ARCHITECT'S SUPPLEMENTAL INSTRUCTION NO. 5

DATE: February 19, 2024 **PROJECT NO:** 230117

RE: Streets of West Pryor – Lot 5 Core & Shell

FLOOR PLAN - POWER
SCALE: 1/8" = 1'-0"

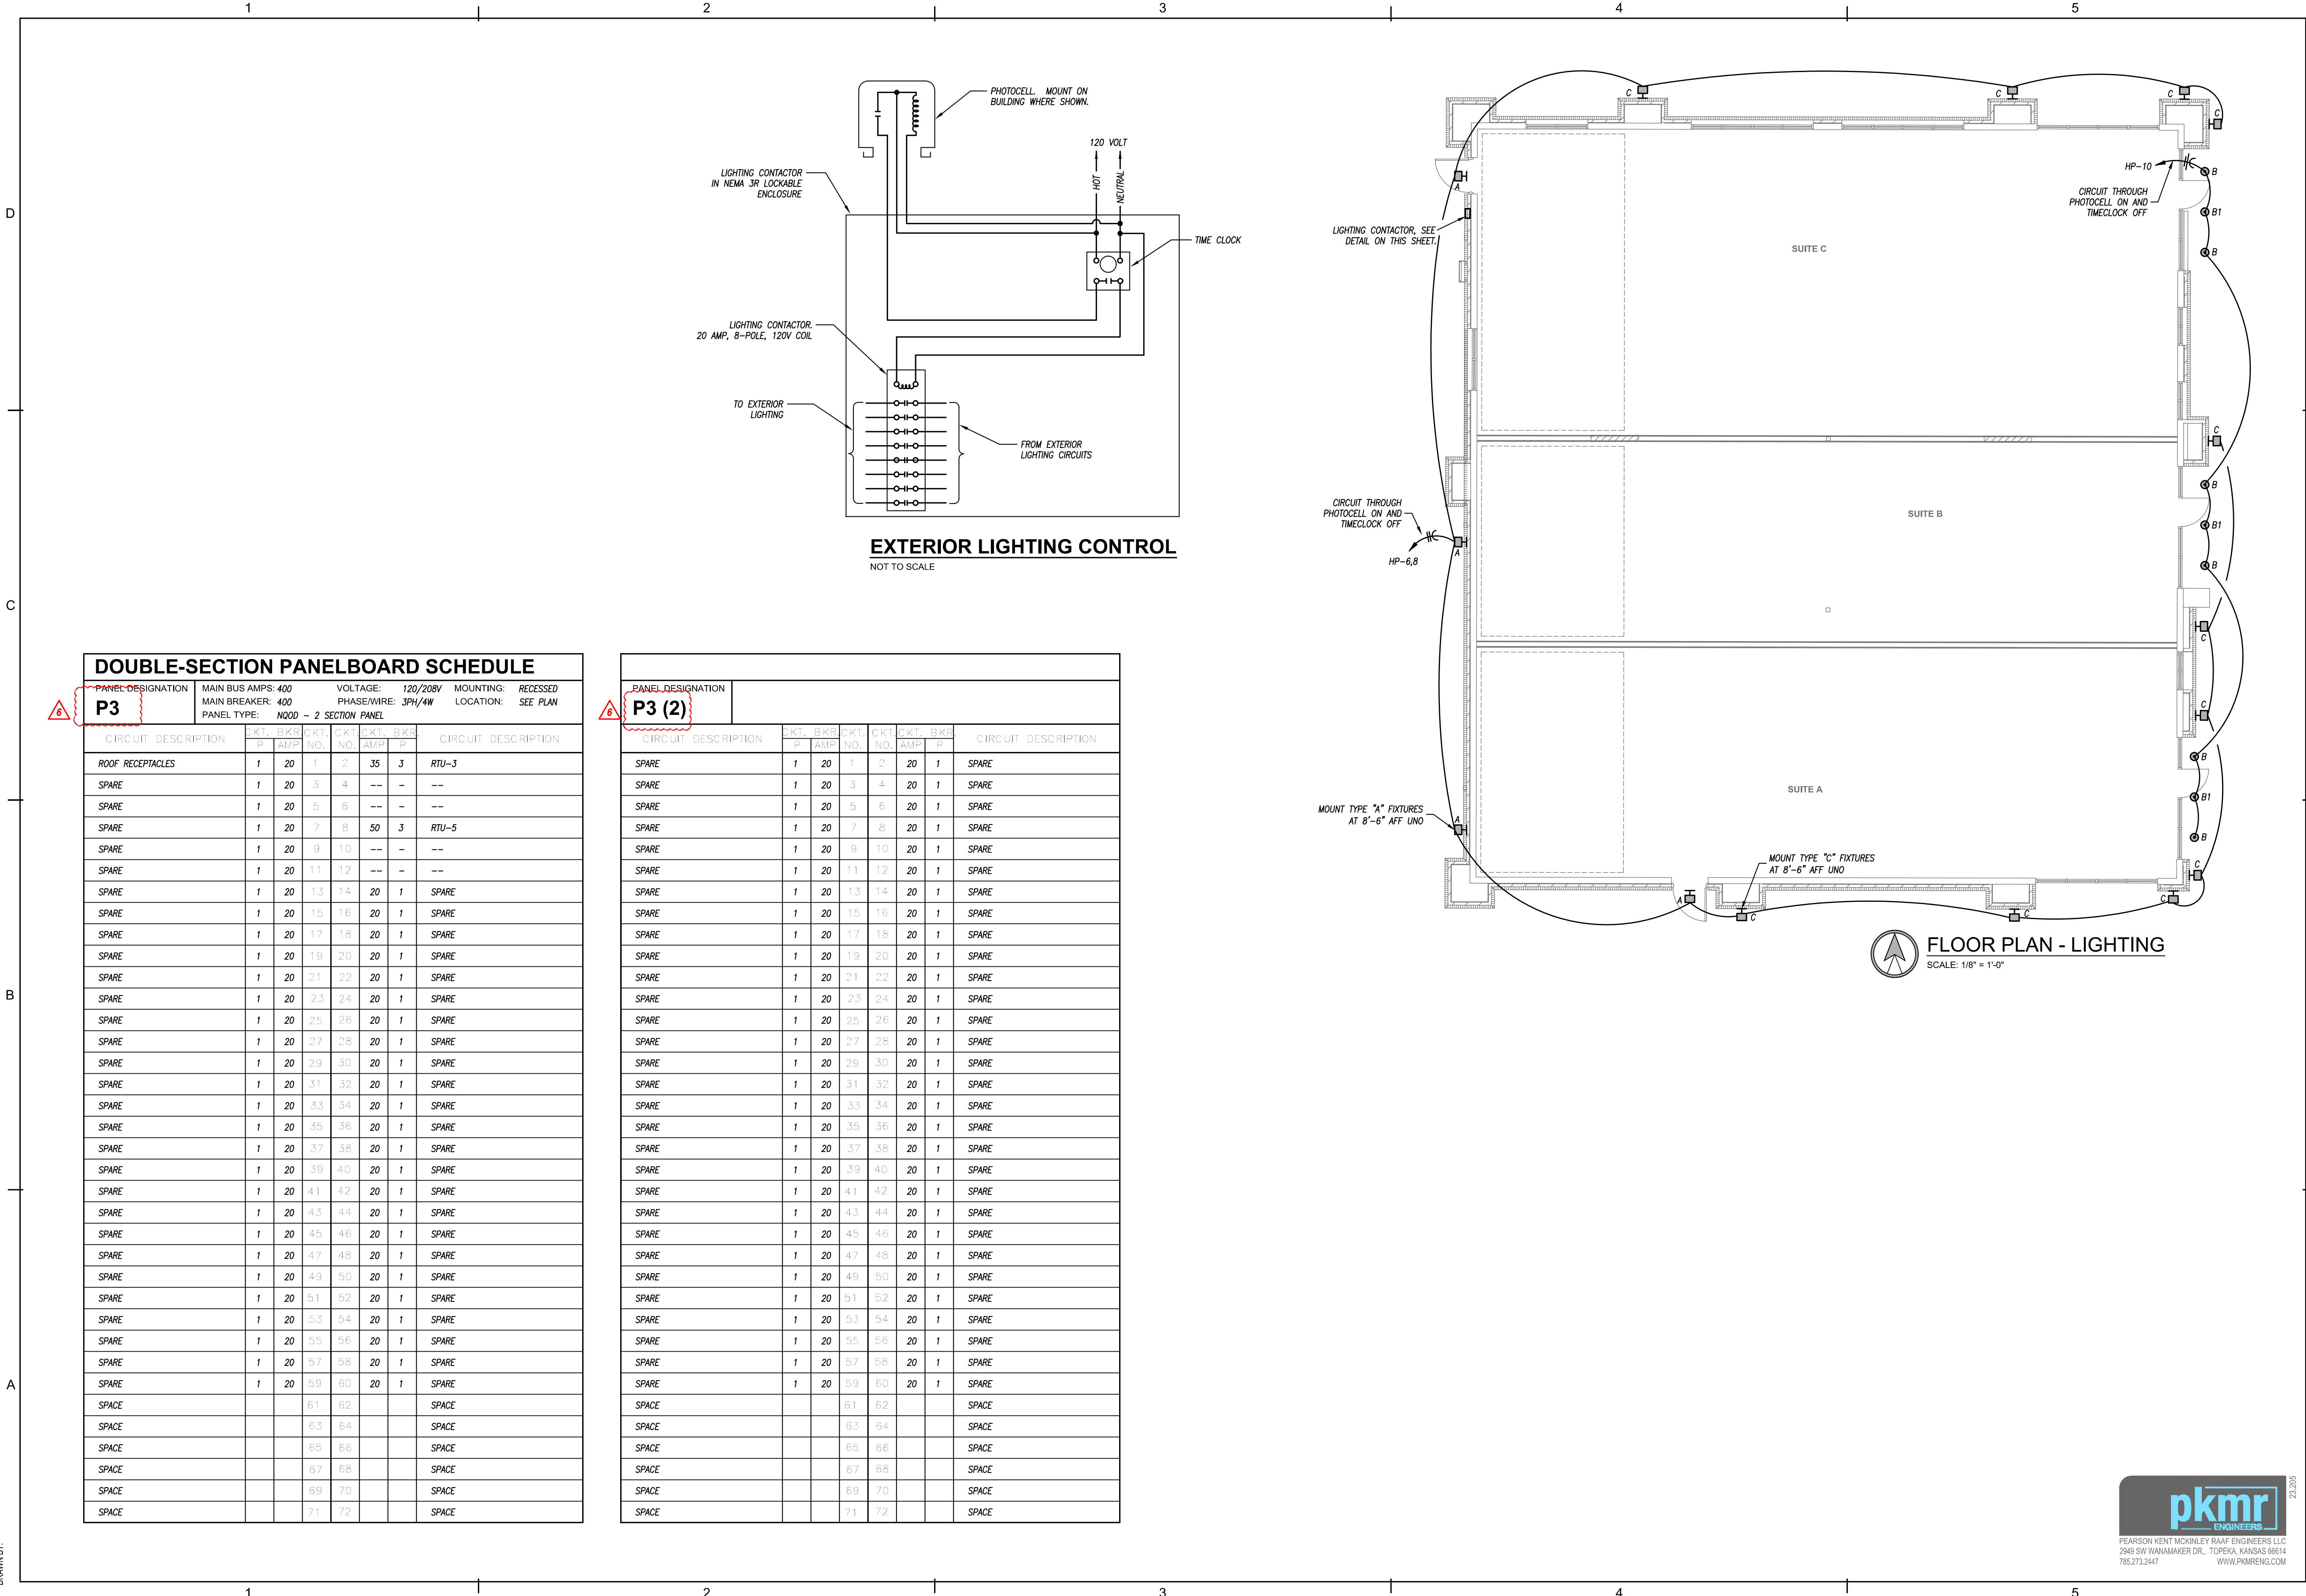
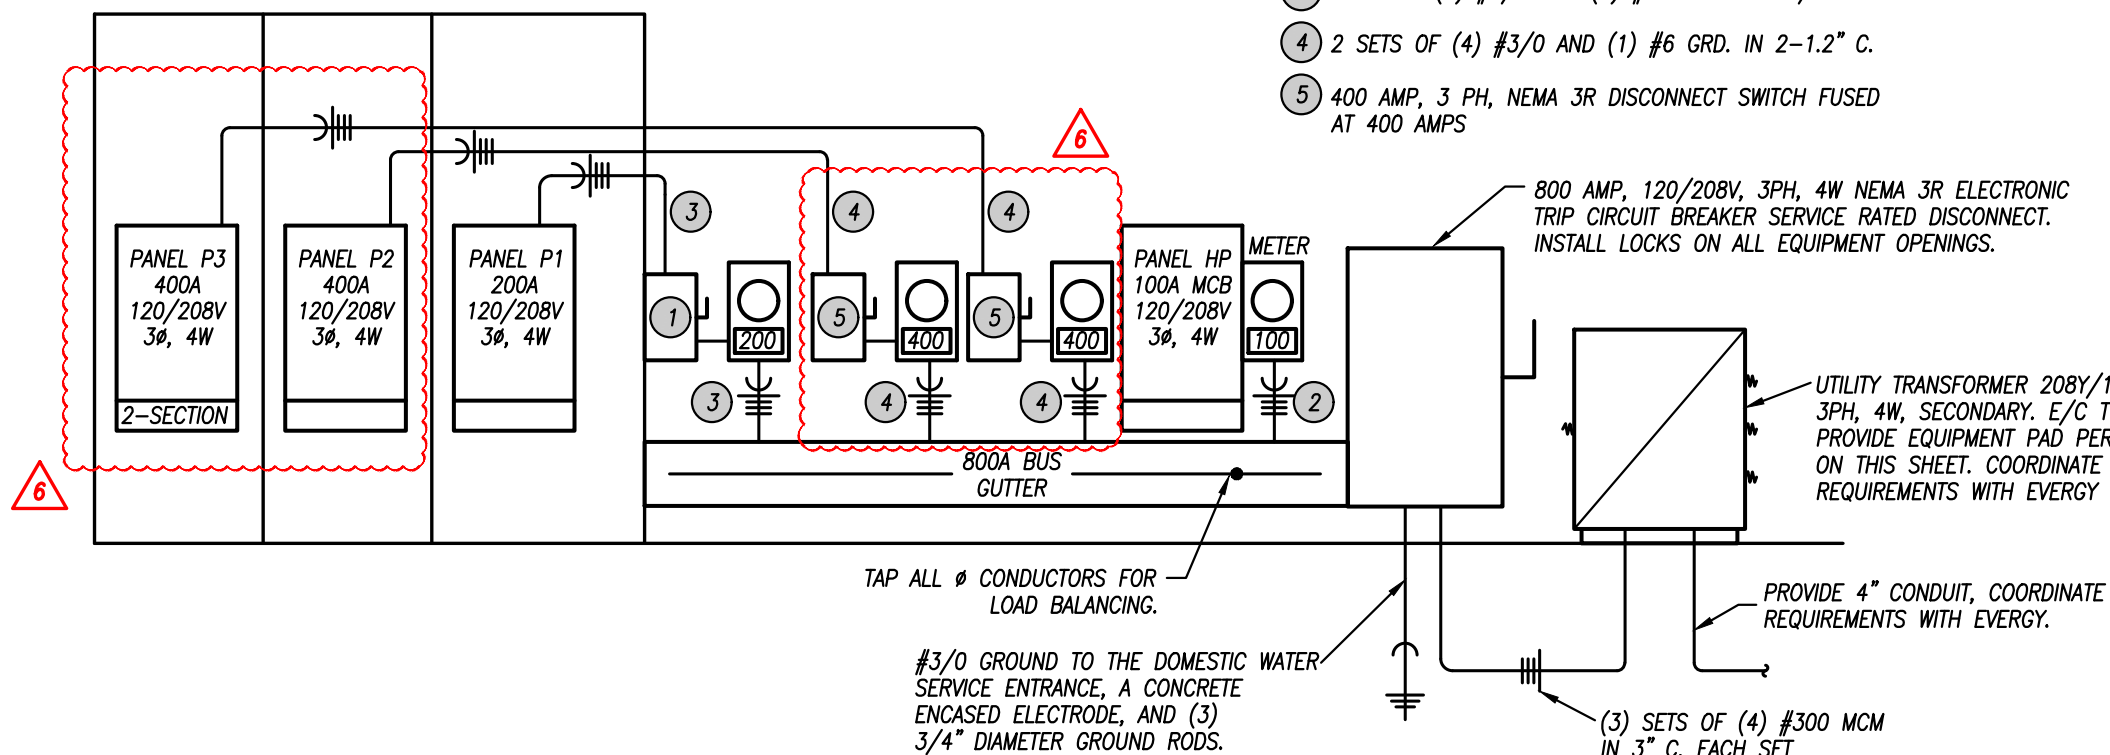
MEP-3 Sheet E-101 – Restroom removed; RTU added to service enlarged Tenant Suite B space.

MEP-3.A Panelboard schedule updated.

MEP-3.B Electrical riser diagram updated with 400A panels.

MEP-3.C Electrical Floor Plan – Power updated for tenant suites A & B.
